SUBJECT: FY16 Joint Routine Inspection of Completed Works, Flood Risk Management Project, Genesee River and Dyke Creek, Wellsville, New York (09/23/16)

**Subject: FY16 Joint Routine Inspection of Completed Works, Flood Damage Reduction Project, Genesee River and Dyke Creek, Wellsville, New York (09/23/16)**

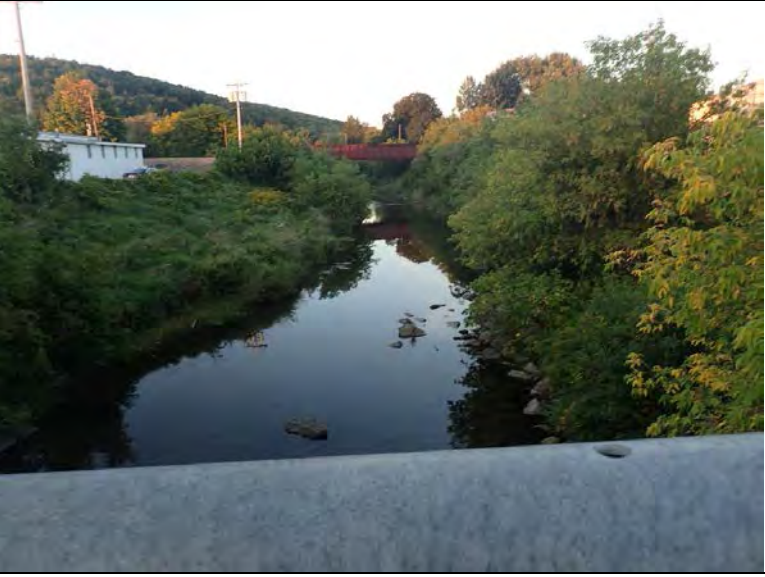
<p><b>Inspect ID:</b> N21R_2016_r_0022 <b>Title:</b> USACE_CELRB_N21R_2016_r_0022_1.jpg <b>Rated Item:</b> 10. Riprap Revetments &amp; Banks <b>Caption:</b> Rating: Unacceptable; Remarks: Significant unwanted vegetation and trees in riprap on both banks between Railroad bridge and Broad Street bridge. (Dyke Creek); Action: Remove unwanted vegetation.; Station_1: 24+00; Station_2: 22+00</p>
	<p><b>Inspect ID:</b> N21R_2016_r_0023 <b>Title:</b> USACE_CELRB_N21R_2016_r_0023_1.jpg <b>Rated Item:</b> 10. Riprap Revetments &amp; Banks <b>Caption:</b> Rating: Unacceptable; Remarks: Significant trees and heavy unwanted vegetation in riprap on both banks between Main Street bridge and Railroad bridge. (Dyke Creek); Action: Remove trees and unwanted vegetation.; Station_1: 22+00; Station_2: 18+00</p>
